ADDENDUM

PROJECT:	<u>A&W Restaurant - North Battleford, SK</u>	DATE:	<u>April 25, 2016</u>
PROJECT #:	<u>15-15</u>		
ADDENDUM #:	<u>1</u>

DWG. NO :
S-2R1.0

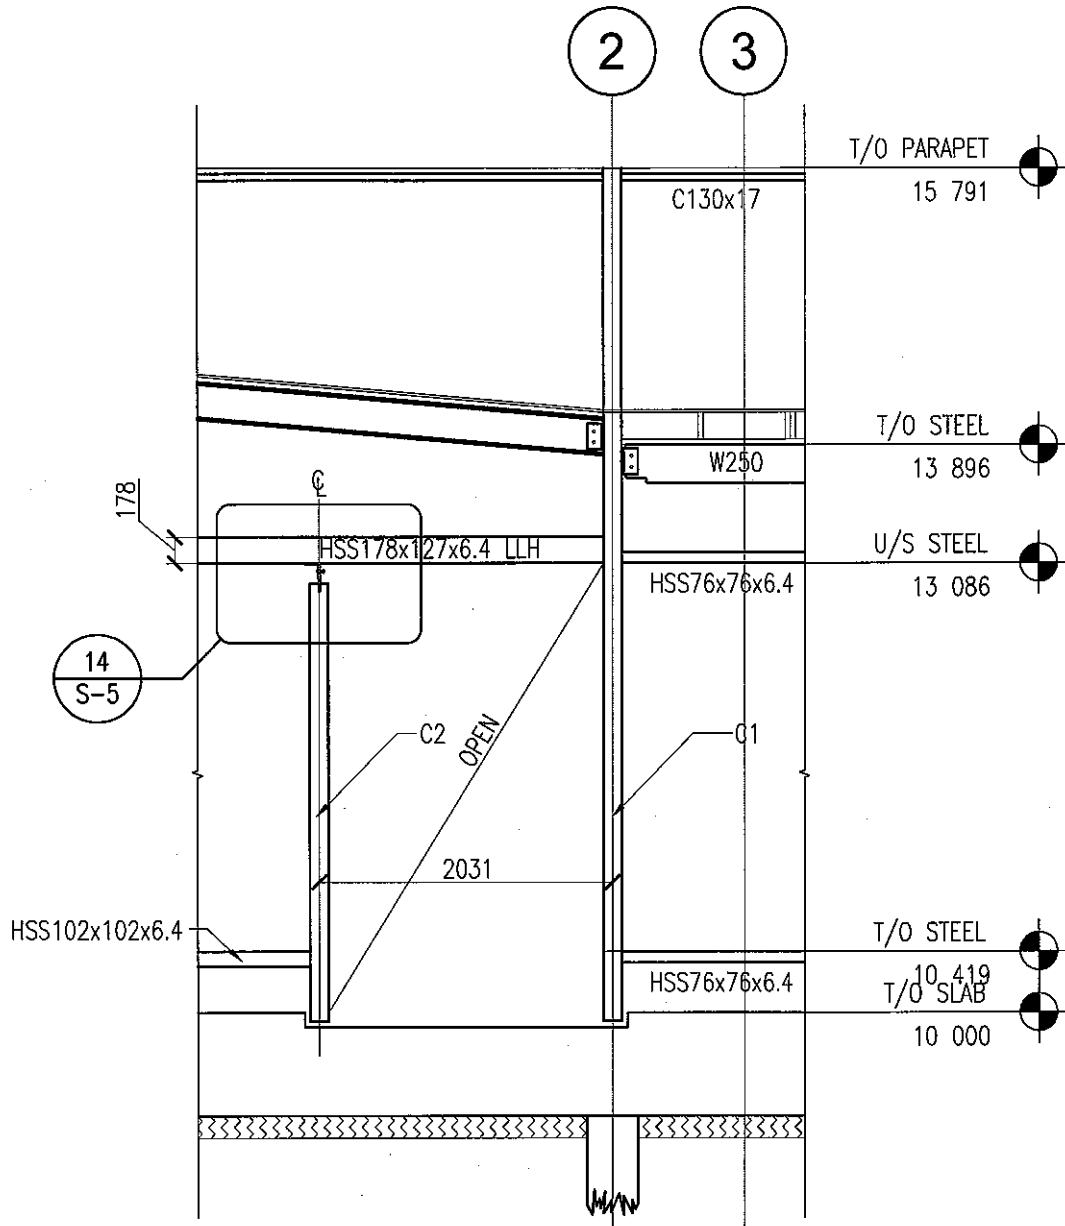
- Detail 1:
 - o Revise floor plan to accommodate relocation of interior vestibule, see attached sketch S-2R1.0.
